# Thor Motor Coach Recall Repair Instructions

Recall # 16V-139

Description/Title: **34J Heatshield**

Affected Product Line(s): **Certain 34J Hurricanes and Windsport Motorhomes**

LOOKING FROM REAR TO FRONT

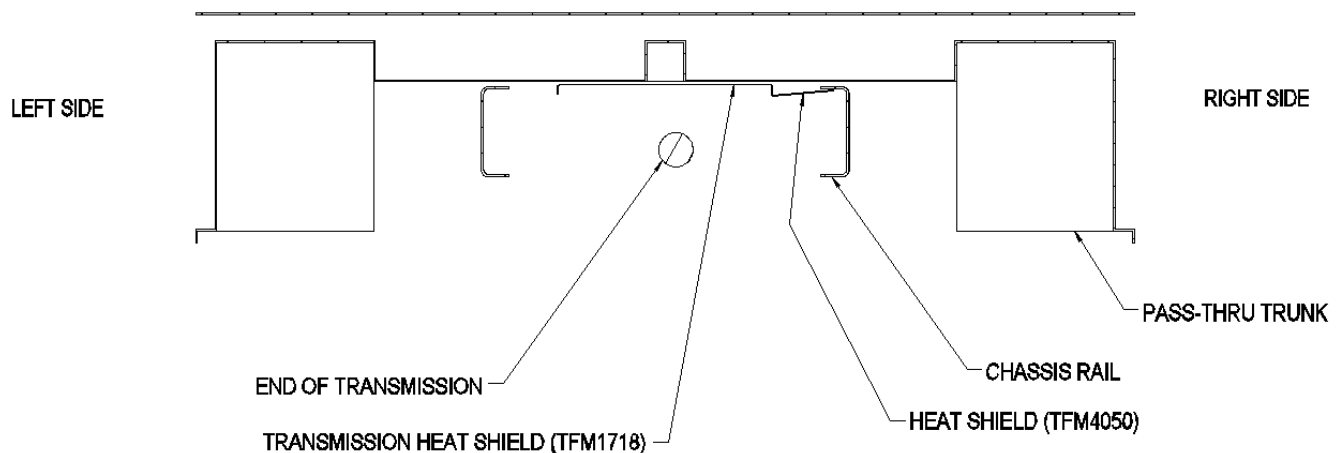
While underneath the coach locate the front truss support on the right hand (passenger) side of the unit.

Take the heat shield and butt the widest side against the front truss.

When positioned properly, the flange on the new heatshield will over lap the flange on the transmission heat shield.

Secure the heatshield with 3/4" hex head self tapping screws.
